**ADDENDUM NO. 3
TO THE
BIDDING DOCUMENTS
FOR
VERNON HILLS WATER SYSTEM ELECTRICAL AND MECHANICAL UPGRADE
FOR
LAKE COUNTY PUBLIC WORKS**

LAKE COUNTY CONTRACT NO. 19062

DATE: May 9, 2019

Sheet No. 56
Drawing No.

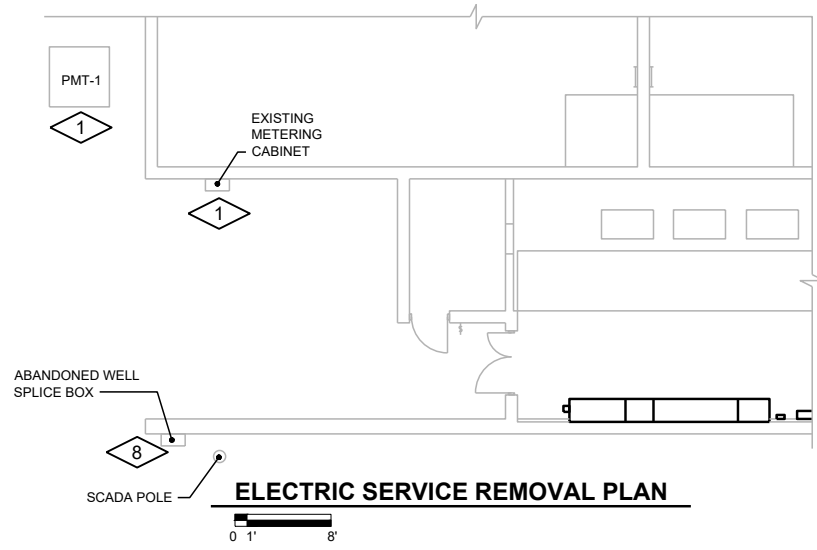
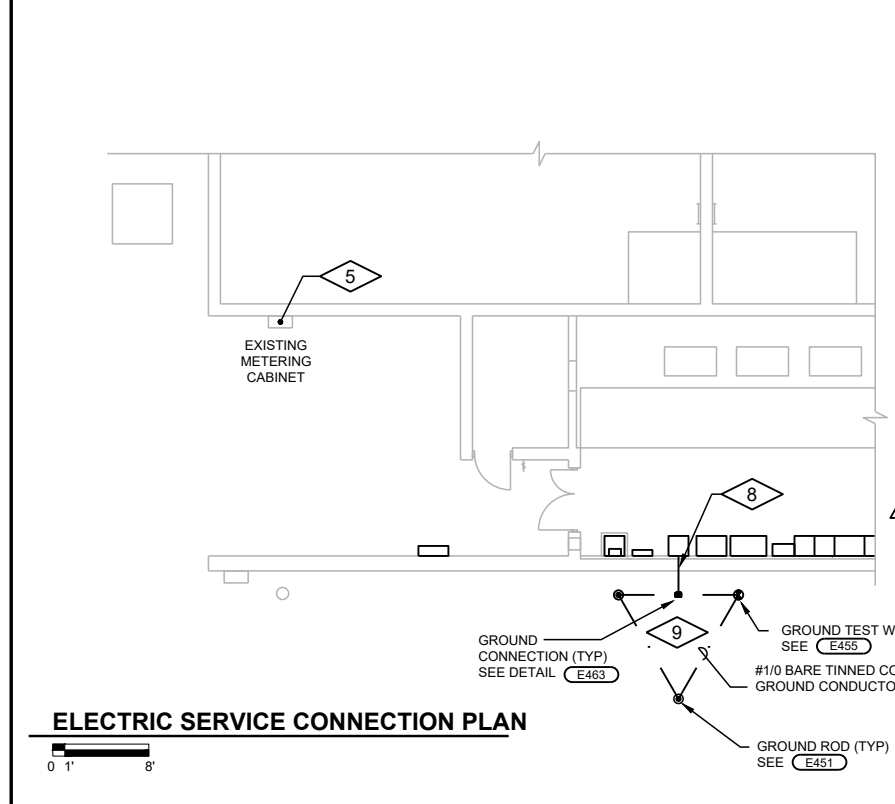
K. Sheet 56 (CWR-R-1): Replace entire sheet with Sheet 56 attached to this Addendum.

**LAKE COUNTY PUBLIC WORKS
WATER SYSTEM ELECTRICAL AND MECHANICAL UPGRADE
VERNON HILLS, IL
CORPORATE WOODS RESERVOIR
PLAN**

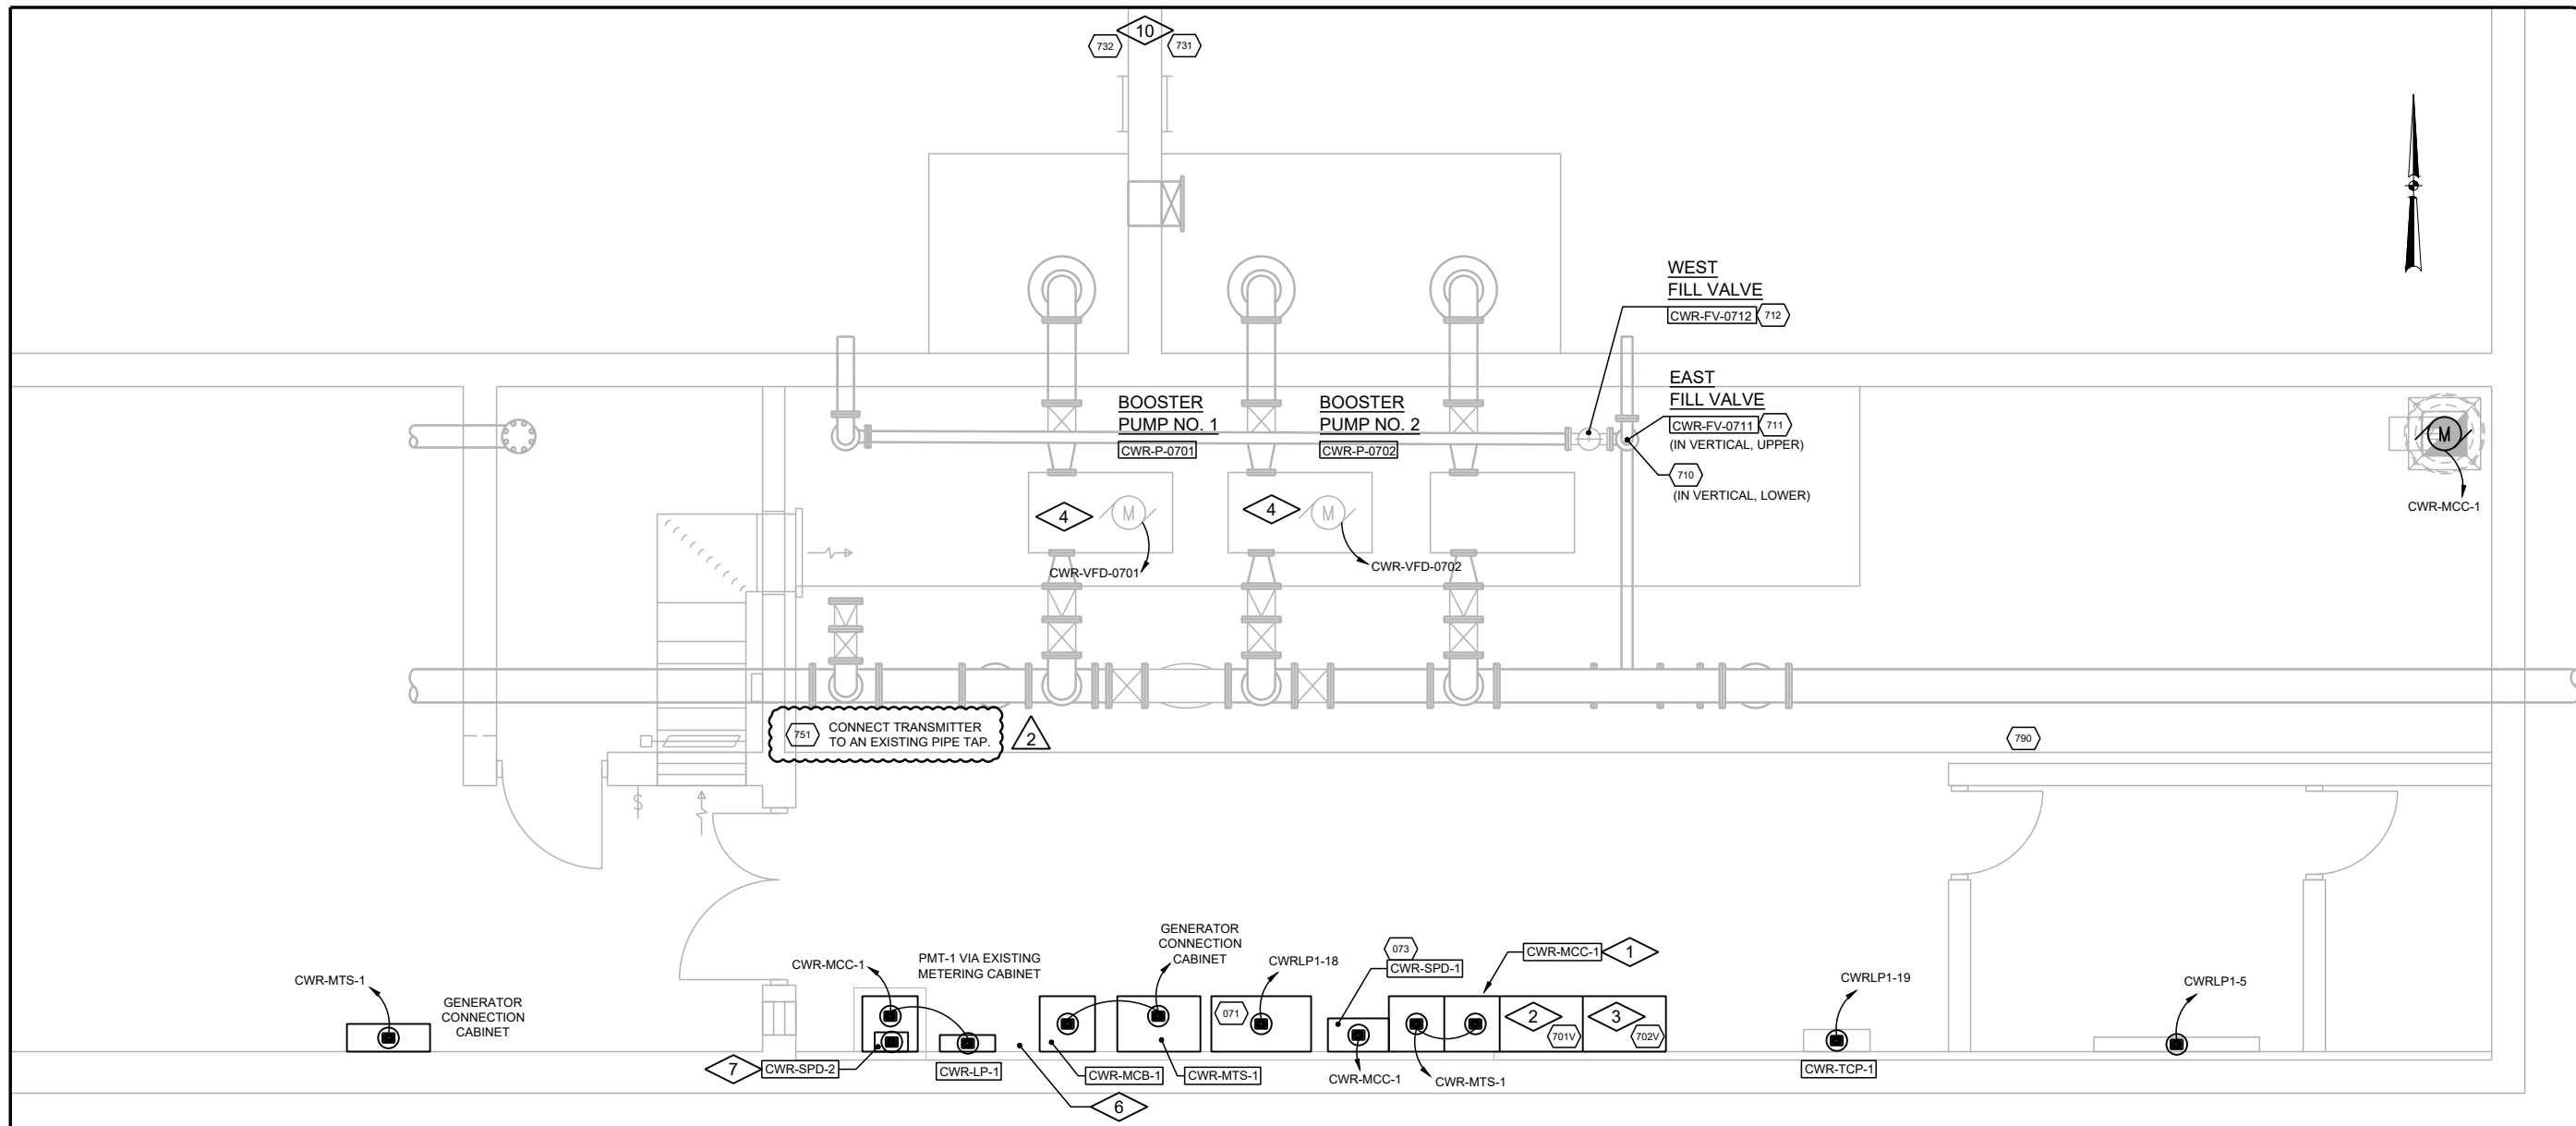
L. Sheet 60 (CWR-EN-1): Replace entire sheet with Sheet 60 attached to this Addendum.
